**CAMBERWELL COAL
PTY LIMITED**

20 February 1992

Camberwell Coal Pty Limited was granted ministerial consent to develop the Camberwell Coal Project on 21 March 1990. Camberwell Coal Pty Limited now wishes to seek an amendment to that consent under Section 102 of the Environmental Planning and Assessment Act to permit the use of tailings dams and pipelines for the disposal of coal washery reject for the balance of the life of the mine which is now understood to be about 20 years. This variation relates to an aspect of the project that was considered but not adopted in the EIS, but which is now required for economical and technical reasons.

LOCATION OF TAILINGS DAMS
WITH FINAL LANDFORM CONTOURS

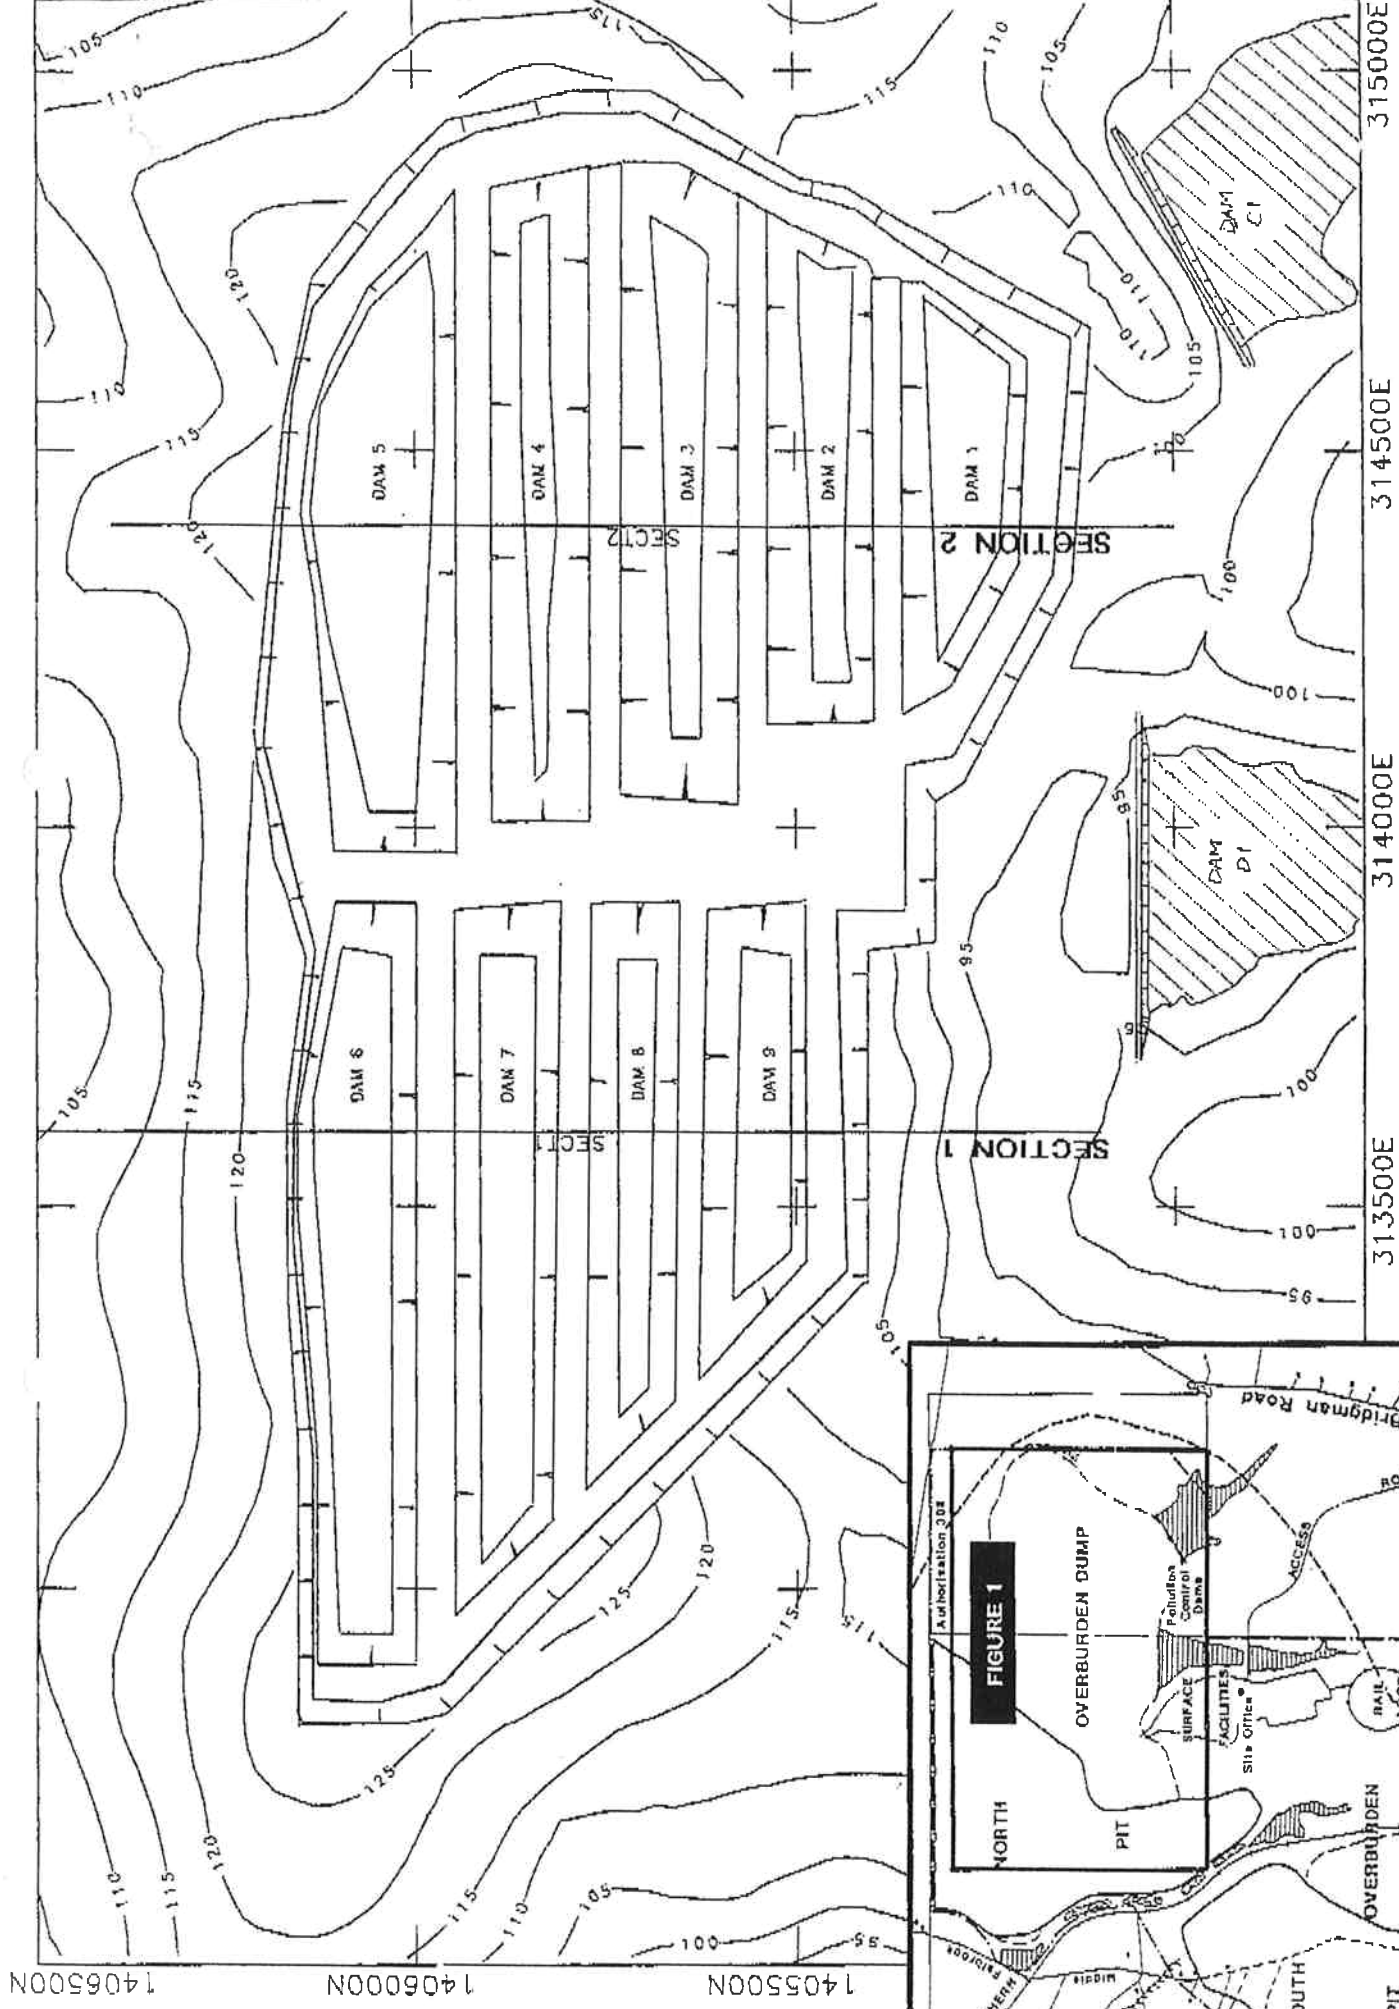
The proposed method for reject disposal is to establish tailings dams over the eastern end of the out-of-pit dump. Fine reject from the preparation plant would be pumped to the dams and the coarse reject would be trucked for disposal with mine waste. The material in the dams would consist of clays and fine particles from the coal seams with a small proportion of flocculant and gypsum. Flocculant and gypsum has been used in the belt press filters as originally planned. Their usage will now be reduced by 90% through the change to tailings dams. Approximately nine dams would be constructed of which two would be in use at any one time, so that a sequence of deposition and drying time can be achieved by alternating between dams. This will also reduce stress on the dividing walls between the dams. The site for the dams is within the area defined in the EIS for waste deposition and is set in a valley that will be surrounded by bulk earth fill. The dam walls are approximately 110-140m wide at the base, 40m wide at the top and have a height of 18-32m. They will be constructed from overburden mined in the normal course of operations and because of their size and location there is a negligible risk of failure. In the unlikely event that this did occur, then the siting of the dams within the valley prevents any major consequences or loss of life. The dams will follow the contour of the final restoration. Although final restoration of the area would be delayed, the tailings dam would be screened by grassed bund walls on the east side which would create a quicker visual restoration than is currently proposed. The bund walls would be used for ultimate backfilling of the dam area, and it is anticipated that restoration of all the dams would be completed within five years of the completion of the mining operations. Dams filled during the life of the mine will be restored on a progressive basis. The profile of the land after restoration will be as described in the EIS. A plan showing the location of the dams and their sequence for use is attached. Also shown are sections through the dams and an approximate timetable for their use and subsequent restoration.
